**RE: Irigaray-Christensen Ranch In Situ Operations, Permit No. 478**

I have reviewed the history surrounding the on-going excursion in the Unit 5 monitor well at the Christensen Ranch Mine, Monitor Well 5MW66.

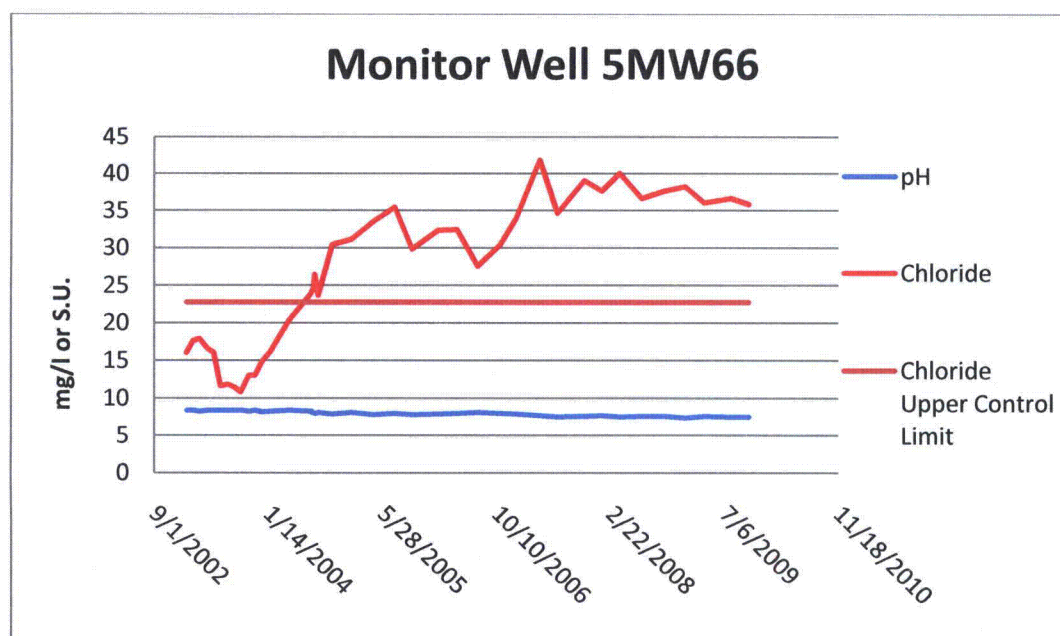
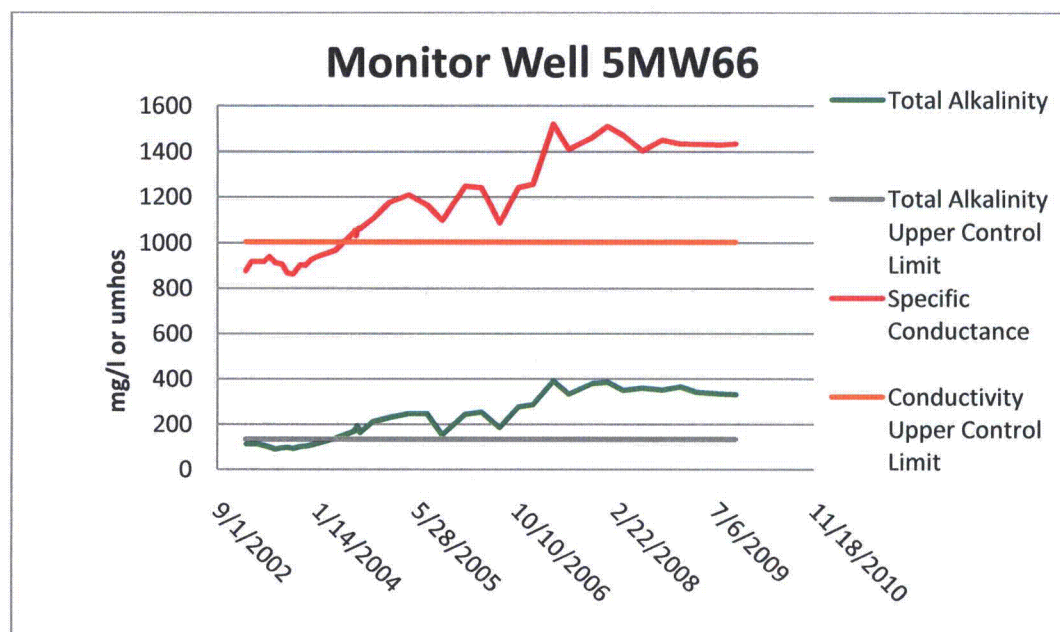
Review of the excursion parameter levels over the past seven years using data from the Annual and SemiAnnual Reports has found that the levels have leveled off, but show no hint that they may drop below the UCLs for many years. The following graphs show these levels.

In addition, it appears that uranium concentrations have dramatically increased over baseline. While no uranium or other analyses beyond the UCLs have been provided directly to WDEQ, an analysis of a sample taken September 17, 2009, was contained in COGEMA's December 30, 2009, response to Ron Linton of the NRC. This analysis showed a uranium level of 2.18 mg/l, a great increase over the 0.234 baseline mean reported back in 1995 for 5MW66 and equally great over the 0.334 mg/l reported for 5MW66 in Tom Nicholson's letter of December 9, 2009.

This increase in uranium levels, a level over seventy (70) times above the Maximum Contaminate Limit (MCL) for uranium, in a well that is located at the edge of the aquifer exemption boundary, is a major concern to WDEQ.

1. return Monitor Well 5MW66 to the list of wells on excursion status,
2. begin monitoring 5MW66 on a biweekly basis,
3. sample 5MW66 for uranium and other chemical parameters listed in Land Quality Non Coal Rules and Regulations, Chapter 11, Section 12(d)(i) in addition to the excursion parameters,
4. present a plan and compliance schedule for controlling the excursion as outlined in Land Quality Rules and Regulations, Chapter 11, Section 12(d)(iii),
5. report the status of 5MW66 as required by Land Quality Rules and Regulations, Chapter 11, Section 12(e)(i),(ii) and (iii).
